CITY OF WINTERS PLANNING COMMISSION AGENDA REGULAR MEETING

Tuesday, December 10, 2013 @ 6:30 PM
City of Winters Council Chambers
318 First Street
Winters, CA 95694-1923
Community Development Department
Contact Phone Number (530) 795-4910 #111
Email: maryjo.rodolfa@cityofwinters.org

TO: Honorable Chairman Biasi and Commission Members
DATE: December 10, 2013
THROUGH: John W. Donlevy, Jr., City Manager
FROM: Mary Jo Rodolfa, Management Analyst
SUBJECT: Consideration of Request to Modify the Landscaping Planting Requirement for the Boat Storage Facility at 723 Railroad Avenue

TO: Chairman and Planning Commissioners
DATE: December 10, 2013
THROUGH: John W. Donlevy, Jr., City Manager
FROM: Alan L. Mitchell, City Engineer
SUBJECT: Review of the Conceptual Landscape Plan and Lighting Plan for the Walnut Lane Roundabout

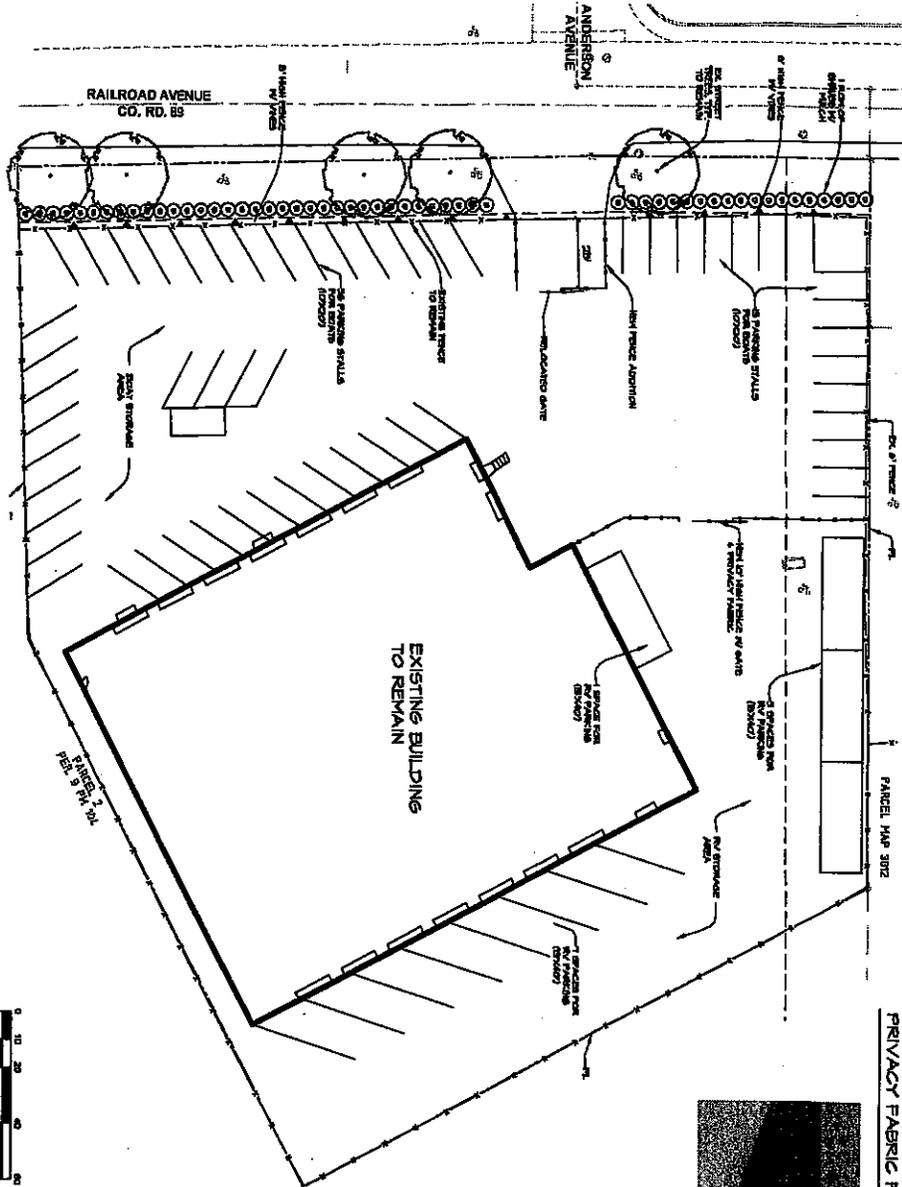
NOTE:
A 2' FOOT CHAIN LINK EXTENSION WILL BE ADDED TO THE EXISTING FENCE ON RAILROAD AVENUE ALONG WITH VINES AND SHRUBS.
